UNITED STATES PATENT AND TRADEMARK OFFICE

APPLICATION NO.	FILING DATE	FIRST NAMED INVENTOR	ATTORNEY DOCKET NO.	CONFIRMATION NO.
10/725,065	12/01/2003	Yueh-Se (Joseph) Huang	GP-303205	2738

Office Action Summary

DETAILED ACTION

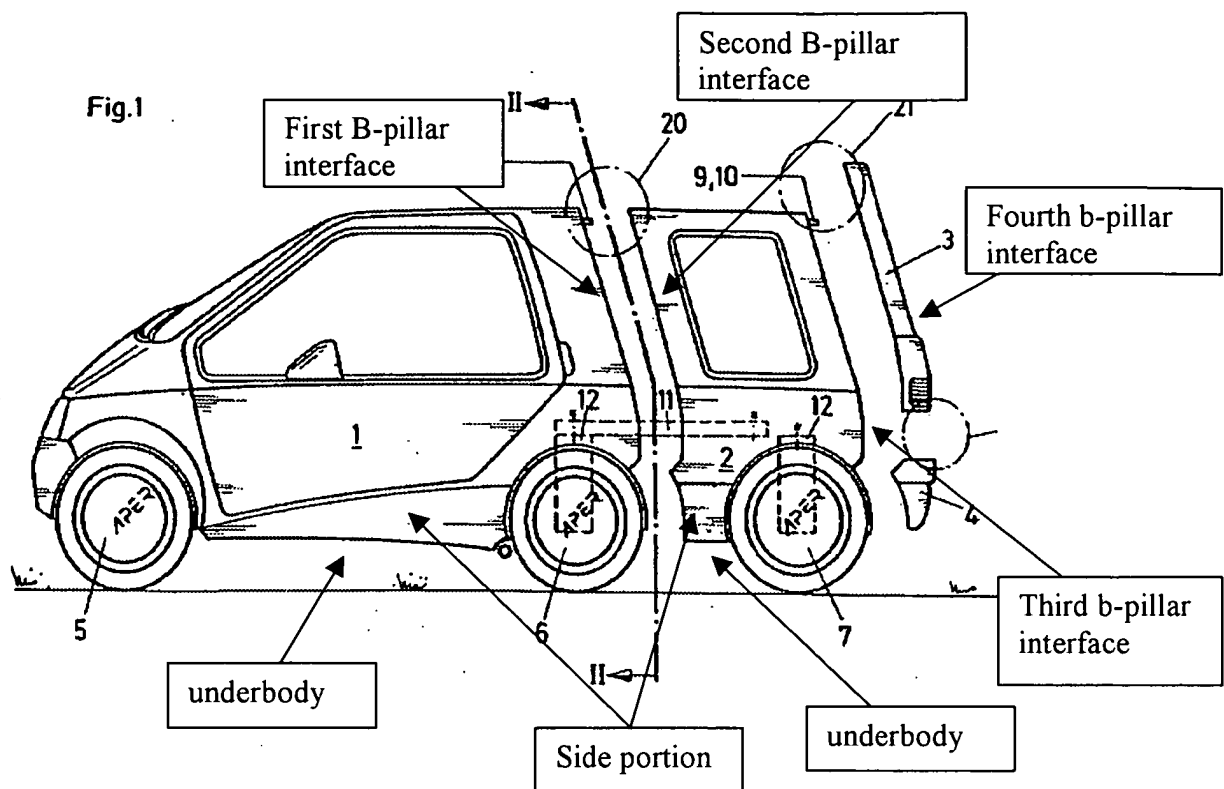
Regarding claims 1 and 8, Aper discloses a modular body for a vehicle, comprising: a first module (1) having a first B-pillar interface (see below); and a second module (2) having a second B-pillar interface (see below); wherein the first (1) and second (2) modules are joined at the first and second B-pillar interfaces defining a B-pillar thereat.

Regarding claim 2, Aper discloses the modular body of Claim 1, wherein: the first module (1) includes two side portions (Fig. 2) and an underbody portion (Fig. 2); the second module (2) includes two side portions and an underbody portion; and the underbody portions of the first and second modules make up an underbody portion of the vehicle (see illustration above).

Regarding claim 4, Aper discloses the modular body of Claim 1, wherein the second module (2) further includes a third B-pillar interface (see above), and further comprising: a third

module (3) having a fourth B-pillar interface (see above); wherein the second (2) and third (3) modules are joined at the third and fourth B-pillar interfaces defining a second B-pillar thereat.

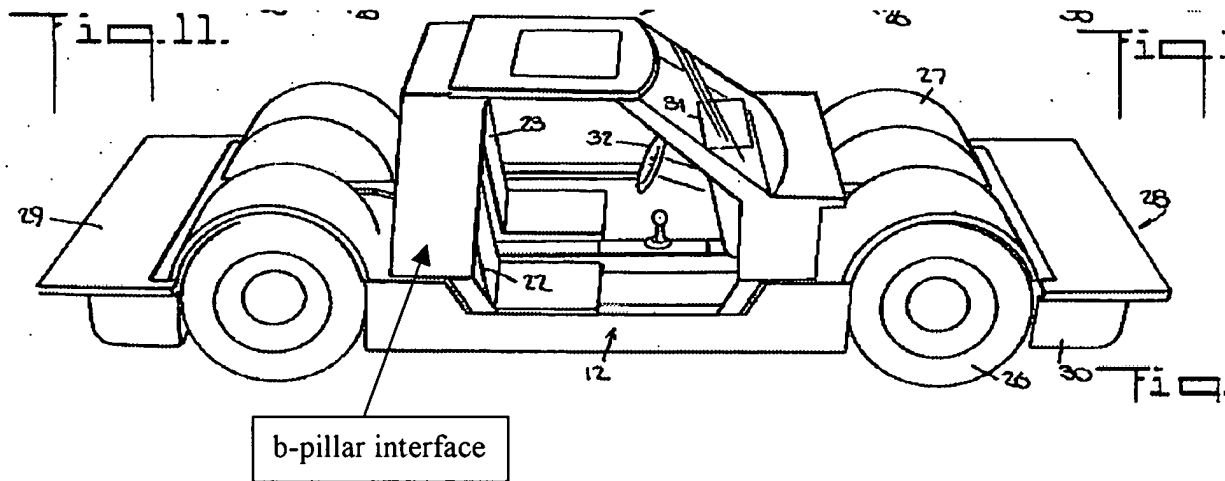
Regarding claim 6, Aper discloses the modular body of Claim 1, wherein the first and second B-pillar interfaces are slidably engaged (in Fig. 3, the bolt 9 which joins the two modules together is welded onto the first module (via bracket 8) and therefore the second module slide onto the bolt of the first module) with each other.
